Throwing Netting and Throwing Curtain Proposal Request

Narrative to proposal request

UK INDOOR TRACK FACILITY

TF-102

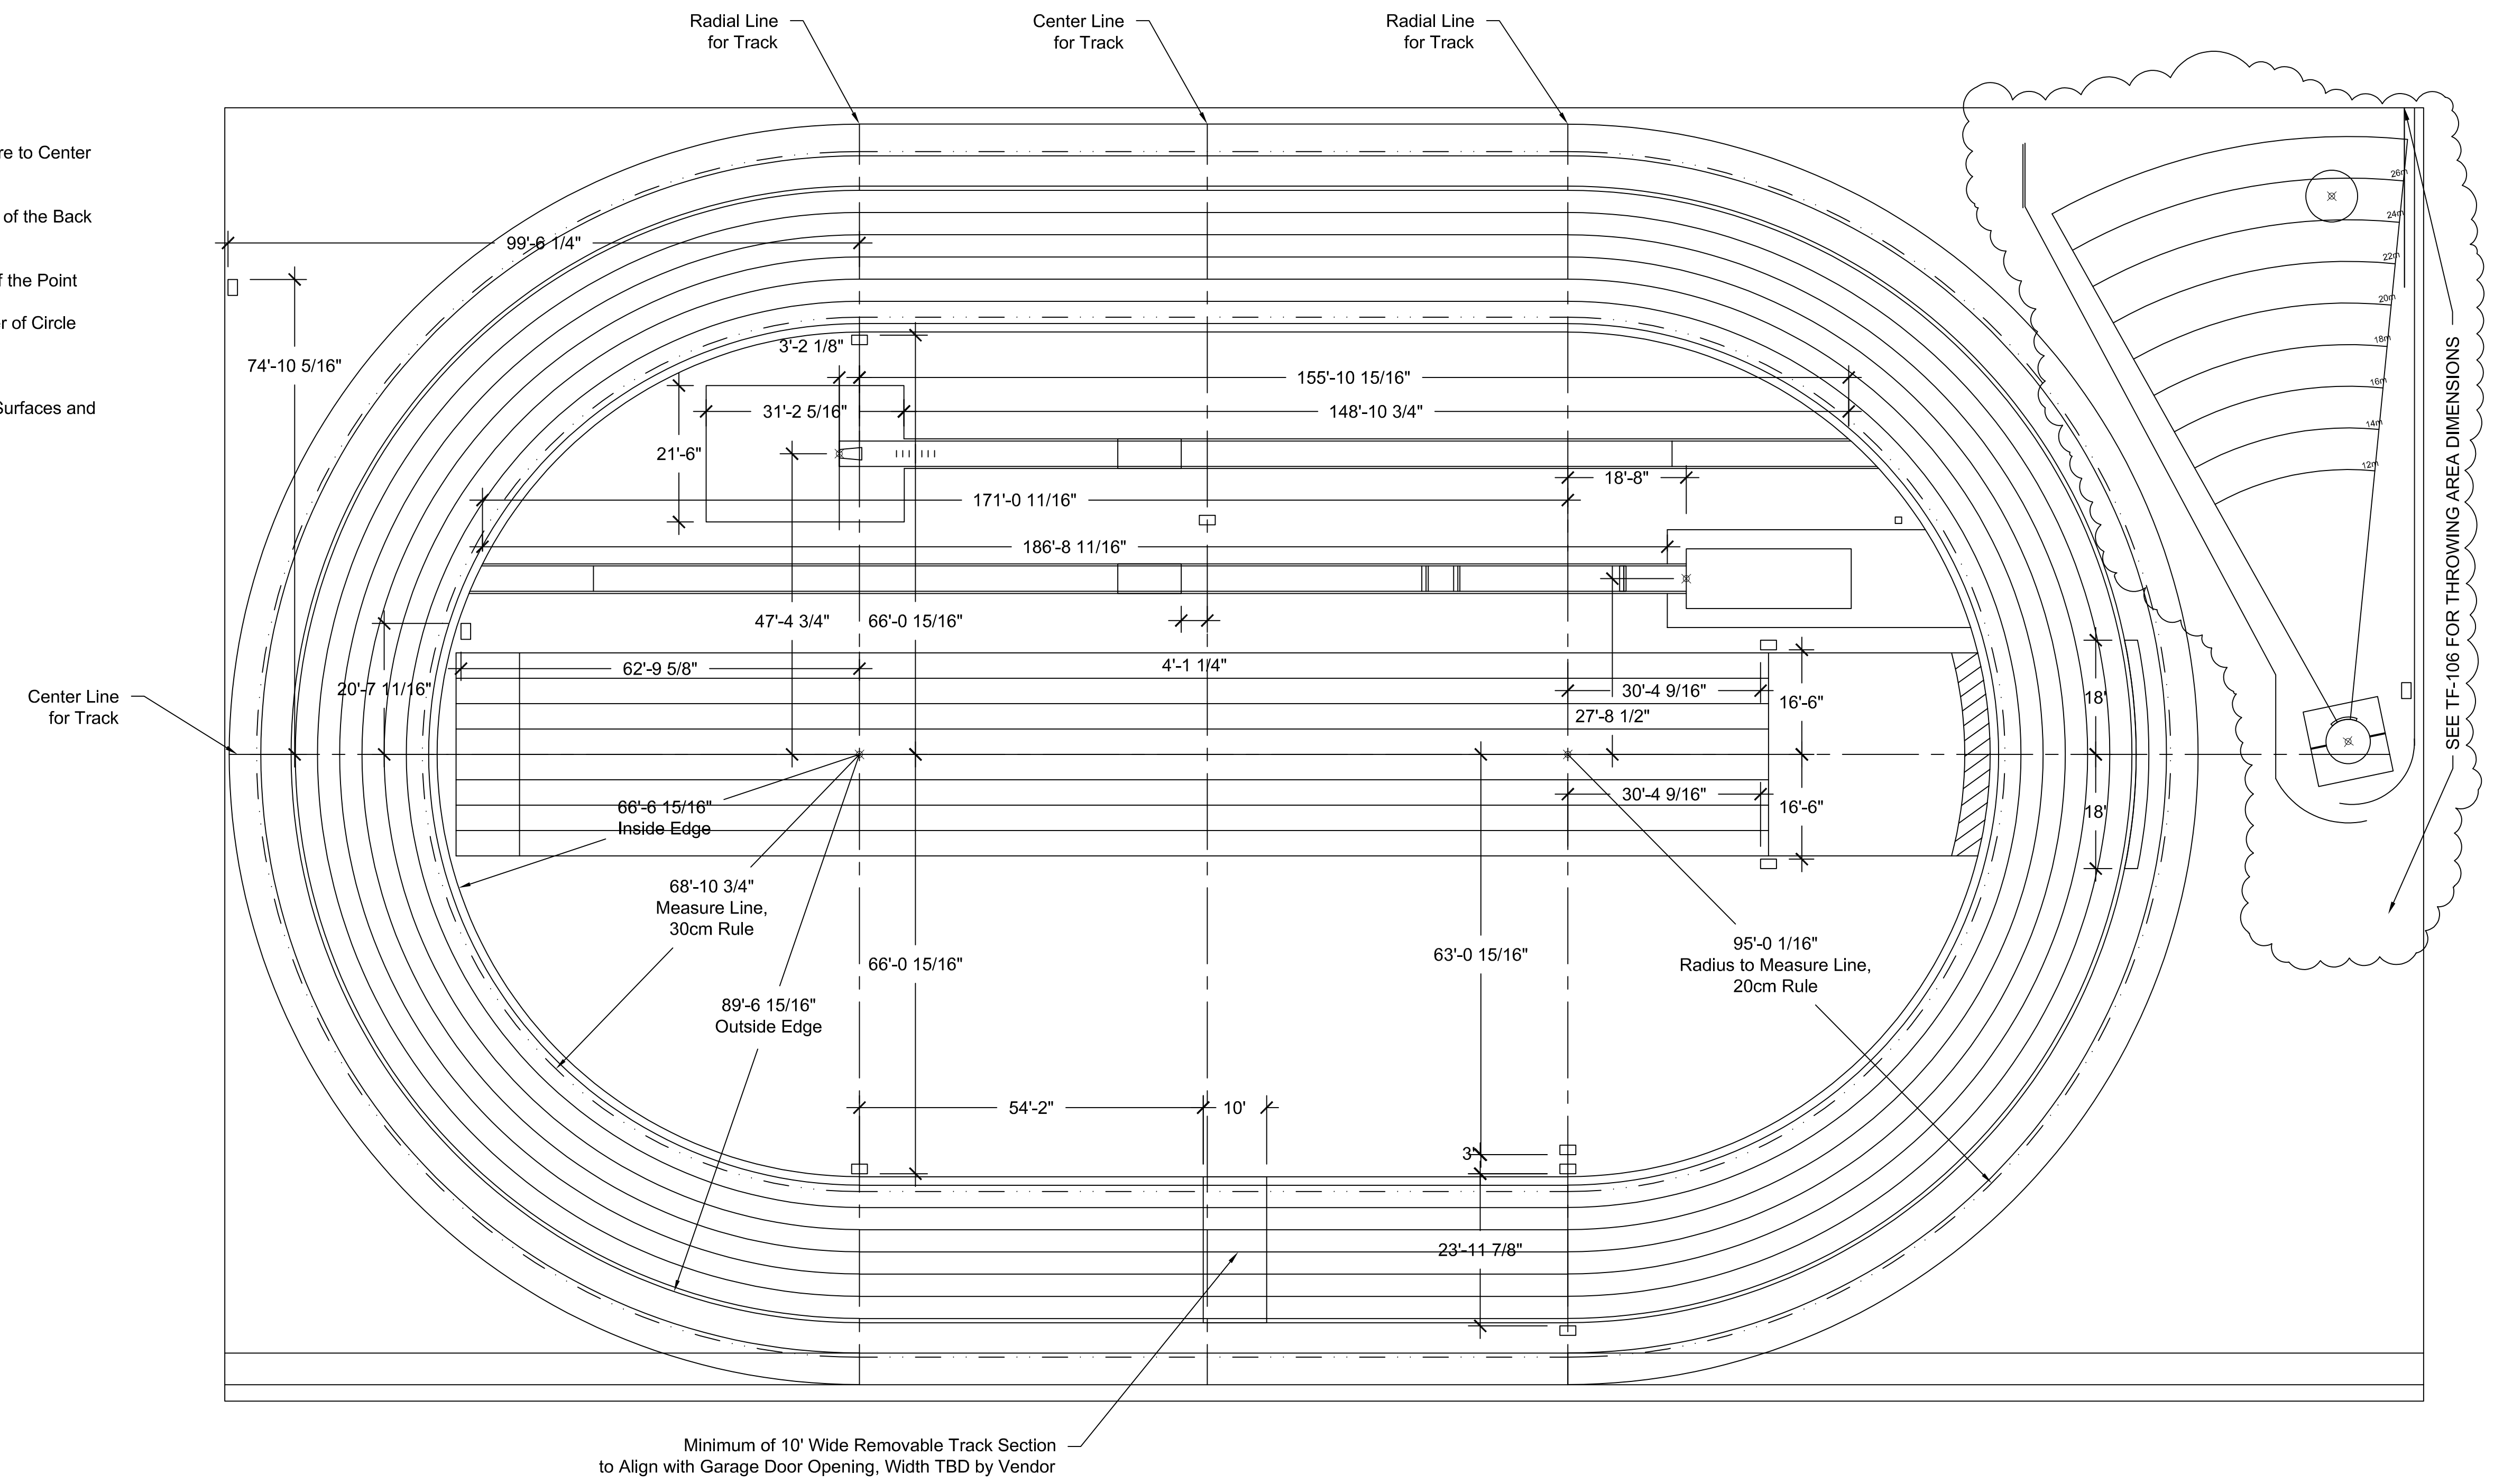
REVISIONS		
No.	Description	Date
1	ADDENDUM 1 - TRACK	9/30/2022
2	NETTING RFP	4/20/2023

6. One net adjacent to the sector lines is called the Throwing Net and it is 30' high
 7. Net must be continuous with no openings to prevent any implement from leaving the enclosed netting system.

8. Net to have a weighted tube at the bottom, padded and enclosed in a 9" high black vinyl pocket and 3" above the floor.
 9. The net is suspended from the trusses via black cables and mounted to steel tubes. These steel tubes are mounted to the trusses and these must be provided by this Manufacturer, the color of the steel tubes TBD by the Architect. These materials must be strong enough to support this netting system.
